PROJECT
CONCEPTUAL 999, 2017
REVISIONS
UPPER LEVEL FLOOR PLAN
TITLE
DRAWN
A-2.2

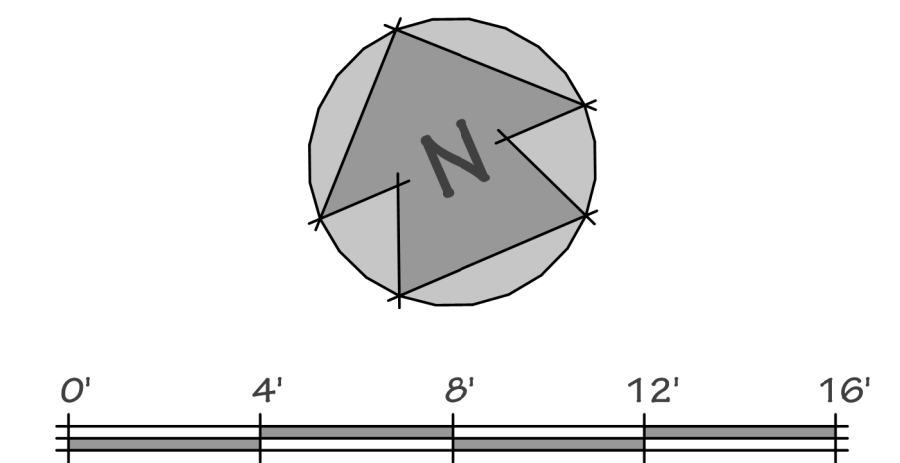
CAN THE SHEAR FORCE OF AREA #1 GO TO LINES 2 AND 3. AREA 1 IS A DECK WITH A ROOF ABOVE. THIS IS WHERE I WAS WONDERING IF I COULD JUST SEND THE FORCE FROM THIS AREA TO LINES 2 AND 3, OR WOULD I HAVE TO LOOK AT THIS ANOTHER WAY FOR BEING AN ATTACHED DECK, AND ROOF LEDGERING ON A HIGHER WALL.

CAN THE SHEAR FORCE OF AREA #2 GO TO LINES 7 OR 8. AREA 2 IS A HIGH FLAT ROOF. THE WALL OF THE POWDER ROOM ON LINE 8 IS NOT CONTINUOUS TO THE ROOF.
